AMENDMENTS TO THE DRAWINGS

Application No. 10/029,973

Title: CHECK VALVE

Responsive to Official Communication dated: November 14, 2003

FIG. 1

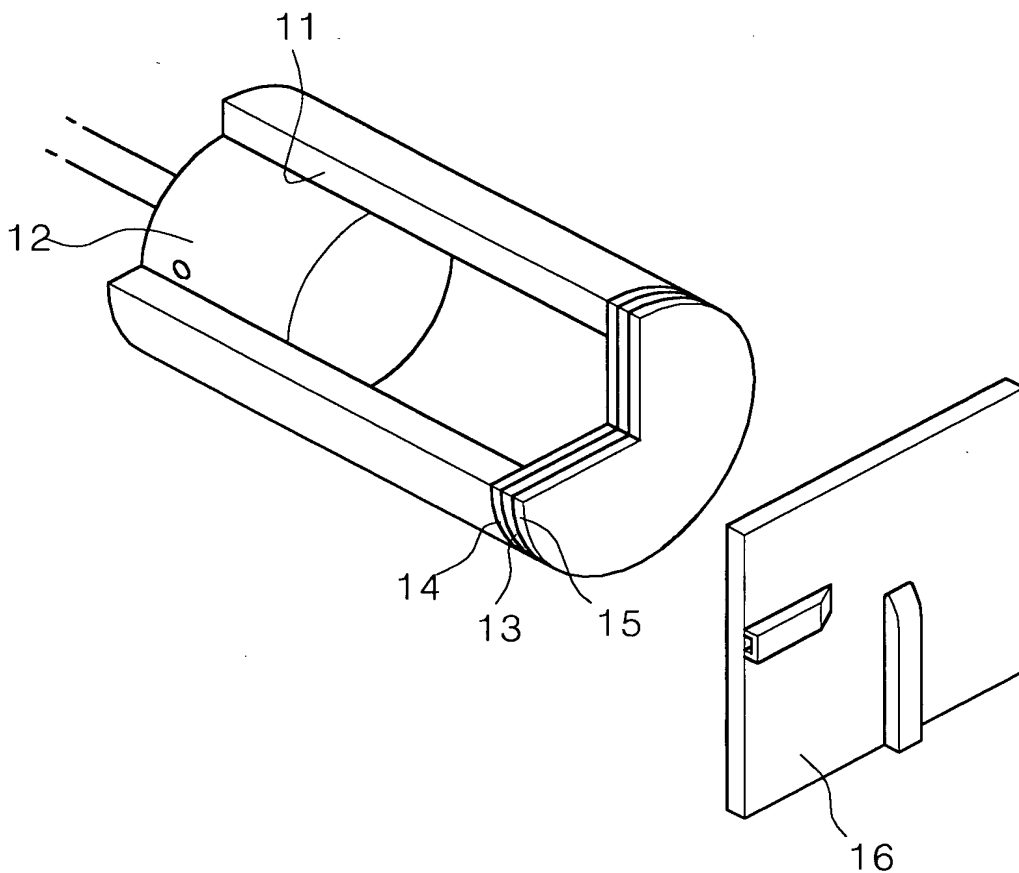
Please replace the three original sheets of drawings containing Figures 1, 2A-2D, 3A and 3B with the three replacement sheets of drawings attached hereto. In the three replacement sheets of drawings, Figures 1, 2A-2D, 3A and 3B have been labeled as "Prior Art".

Prior Art

FIG. 2A

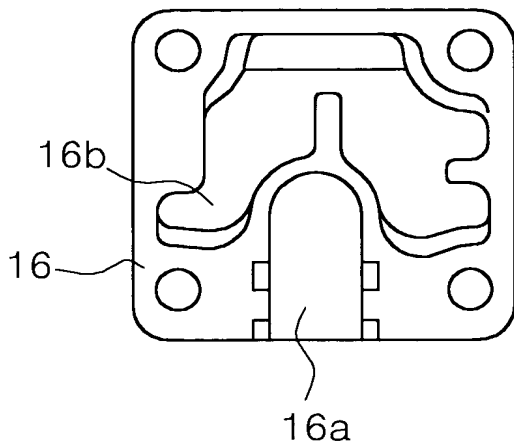
Prior Art

FIG. 2B

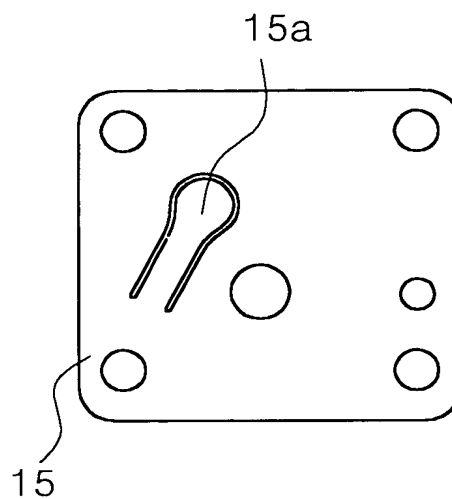
Prior Art

FIG. 2C

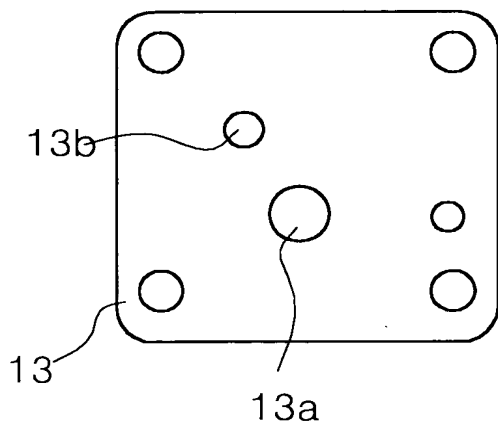
Prior Art

FIG. 2D

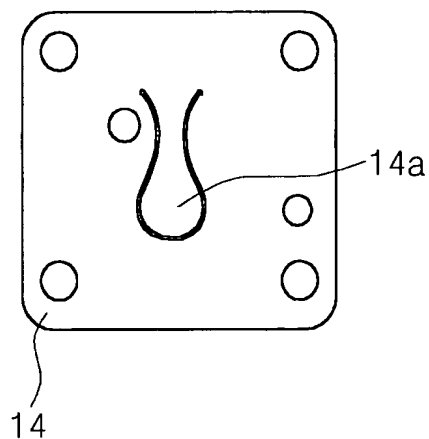
Prior Art

FIG. 3A

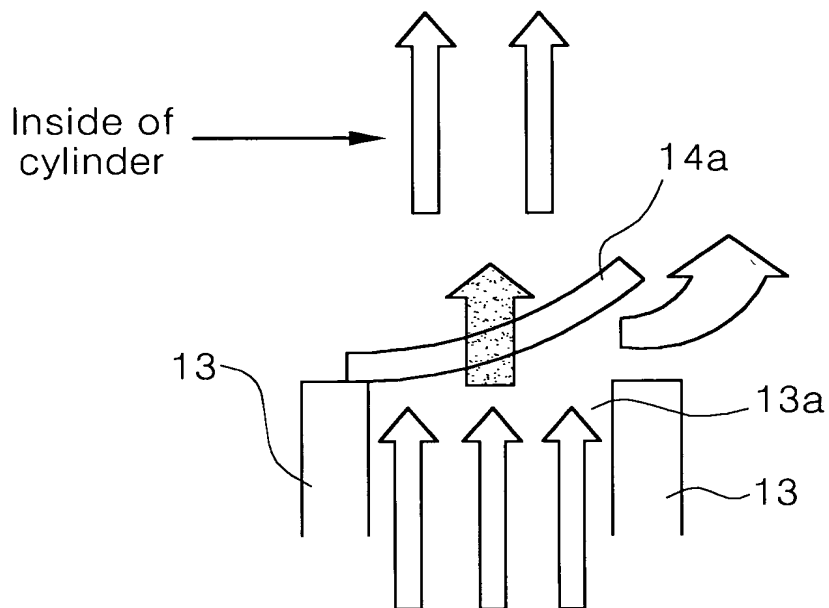
Prior Art
